**RE: Construction Storm Water Inspection at Franklin Station/ Franklin County
Permit Number: 4GC03741*AG**

This letter is written regarding a storm water inspection conducted by Jerome Hoke and Elizabeth Pleta of the Ohio EPA at Franklin Station located on the north side of West Broad Street between North May Avenue and North Mill Street on September 23, 2013. The purpose of the inspection was to evaluate compliance with the General Storm Water Permit associated with Construction Activities. During the inspection, our staff noted the following issues associated with construction activities at this site:

Figure 1: Silt fencing on the northwest corner of site requires maintenance.

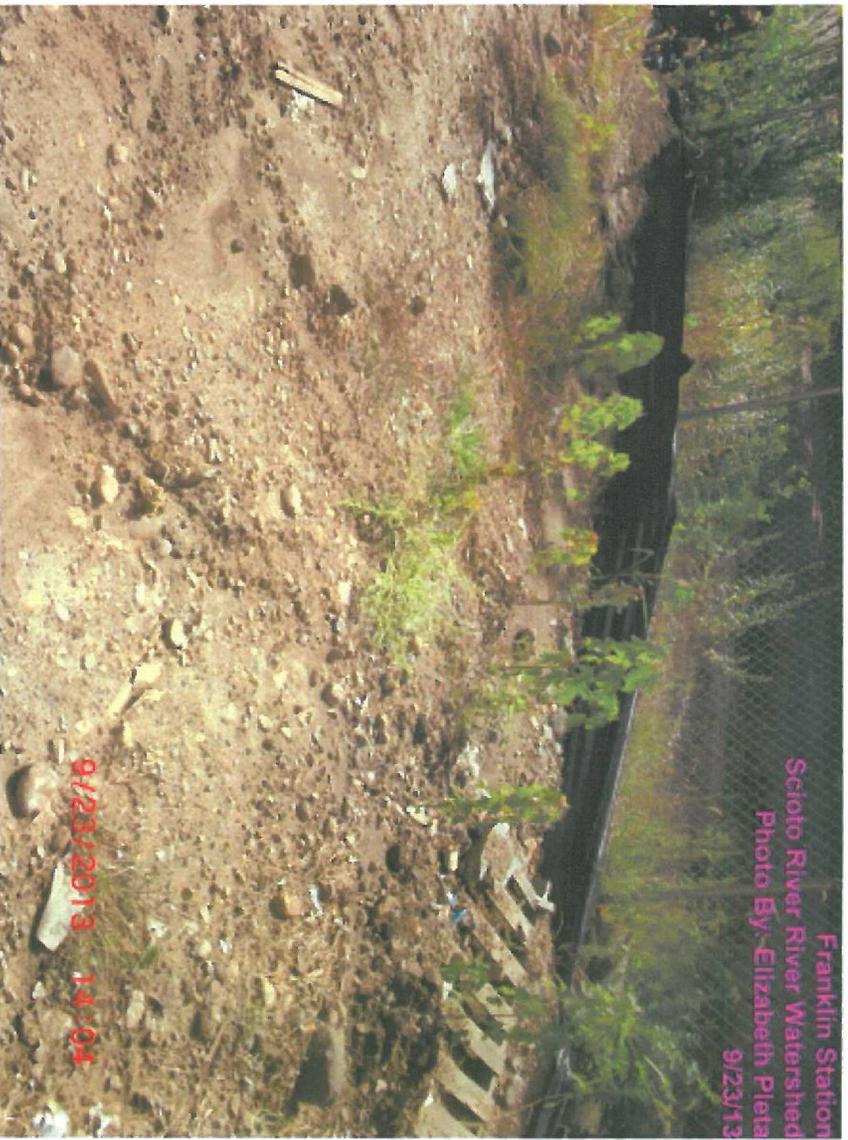
- As noted in a previous inspection, the silt fence in the northwest corner of the site has failed (See Figure 1).
- In addition the perimeter along the southeast side of the site is still void of any sediment controls, directly resulting in sedimentation off-site (See Figure 2).
- Moreover, the integrity of inlet protections on site has further degraded since our last inspection (See Figure 3). Maintenance of silt fencing and inlet protections is expected within three (3) days from receipt of this letter or further compliance measures may have to be taken on behalf of the Ohio EPA.
- At a minimum, all barren areas which are intended to remain idle to through the winter must be protected with a crimped straw mulch or equivalent. Please be aware that this site will be reevaluated to ensure this minimum requirement is
